July 1, 2021

ADDENDUM No. 1

Oregon Central Fire Station

A7.2

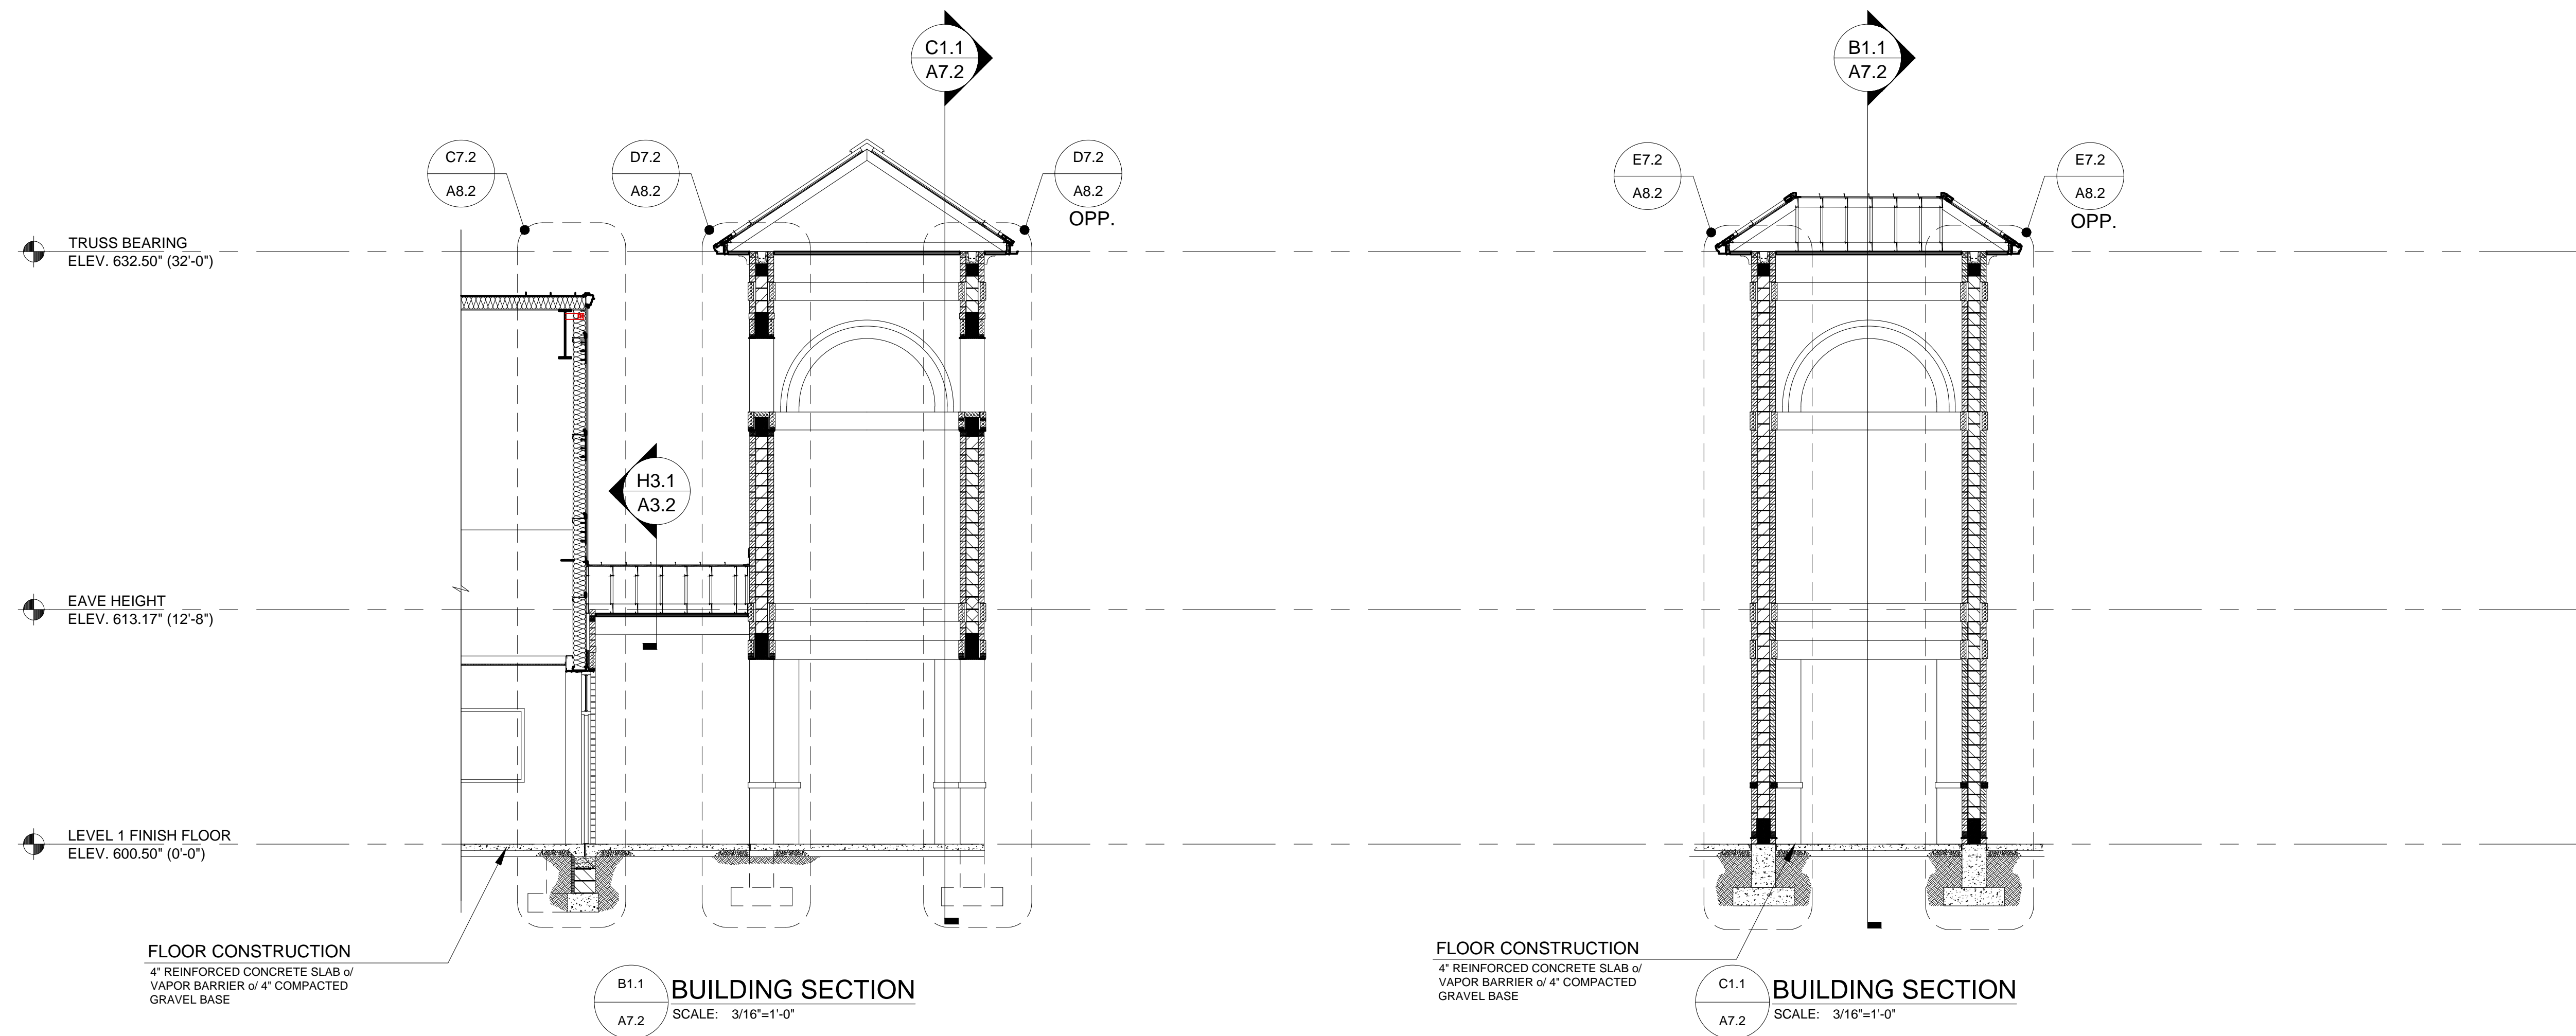
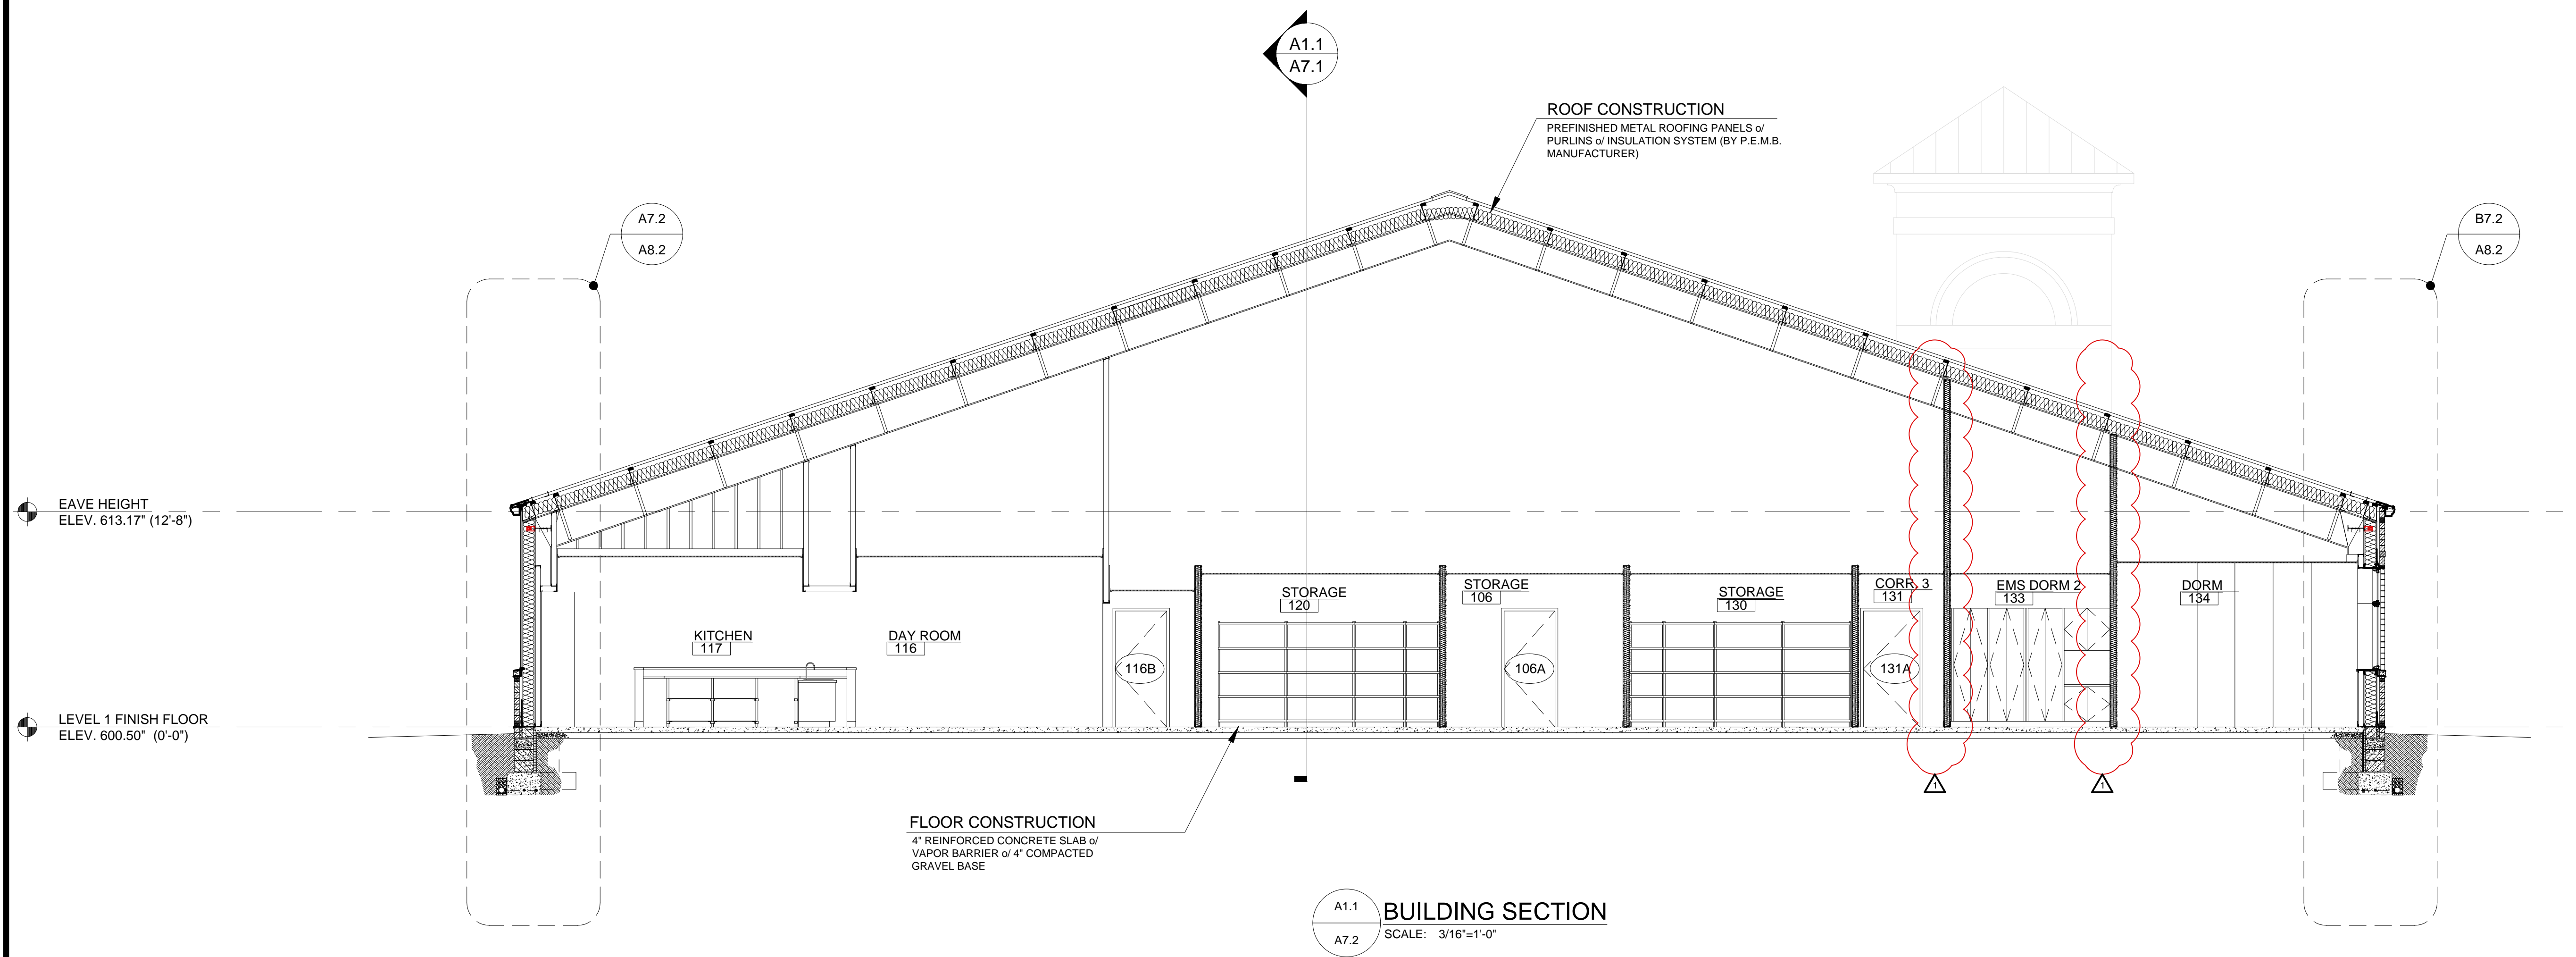
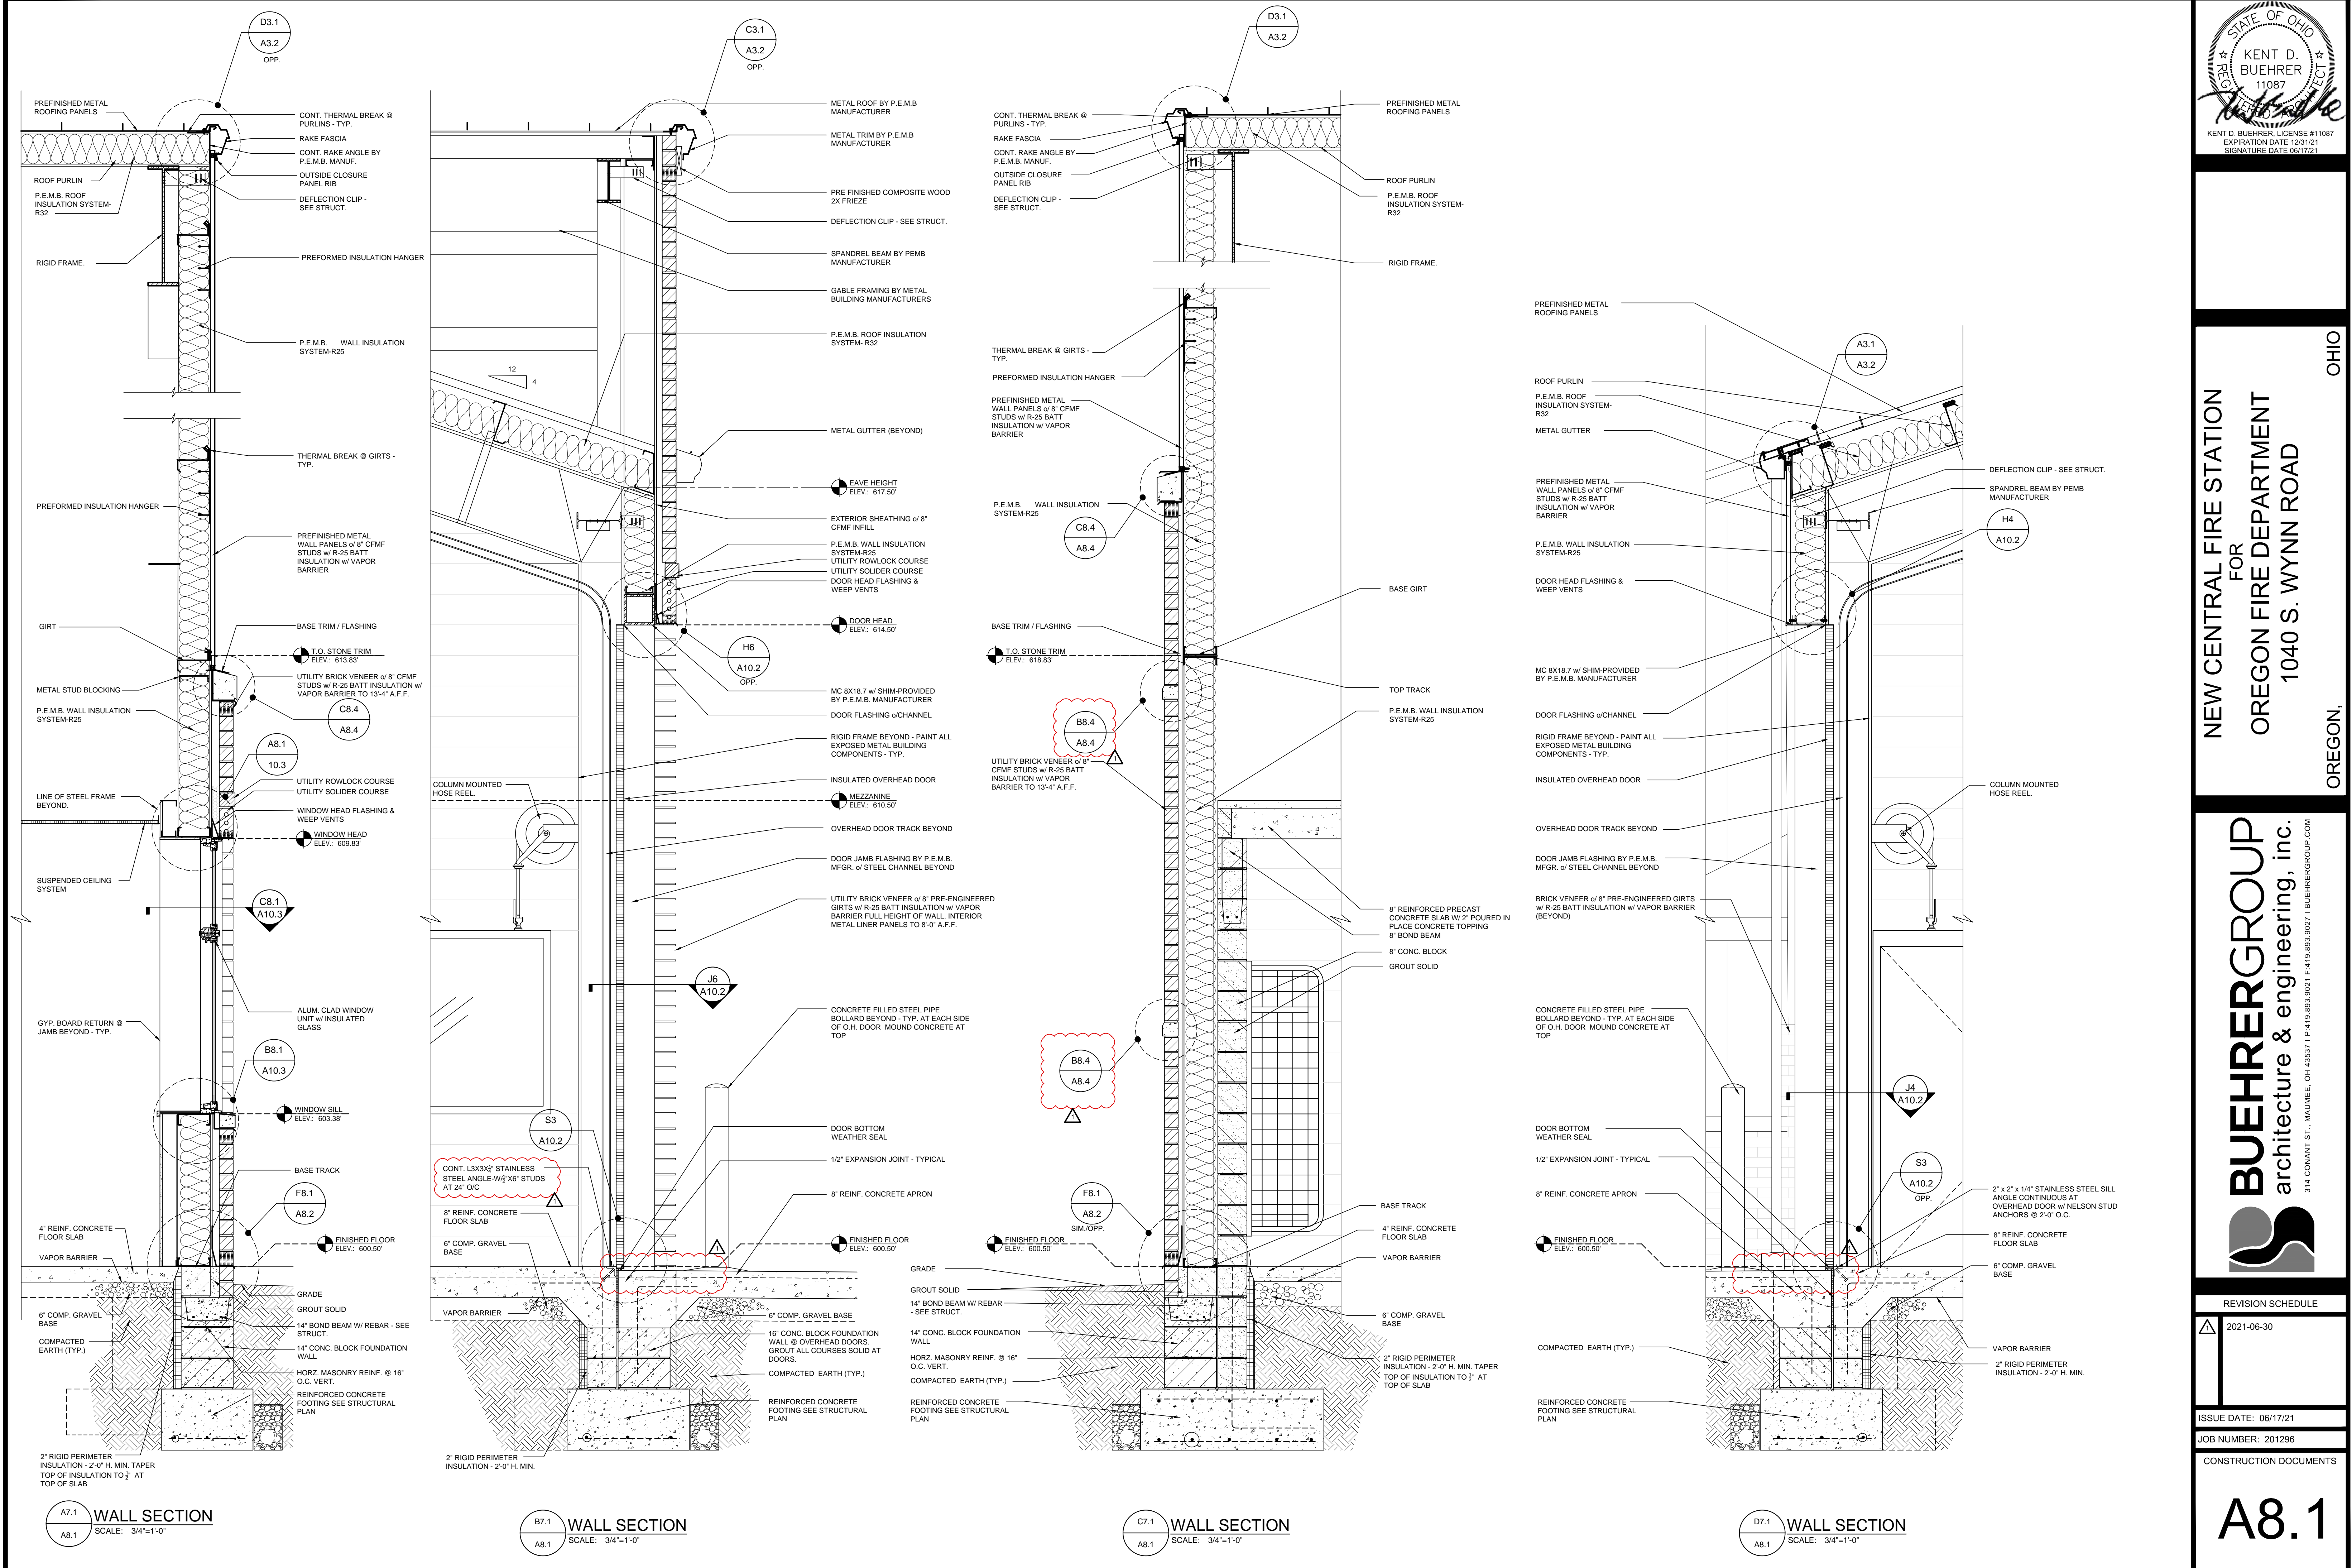
- See attached revised drawing A7.2 for revised wall section heights on Building Section B1.1/A7.2.
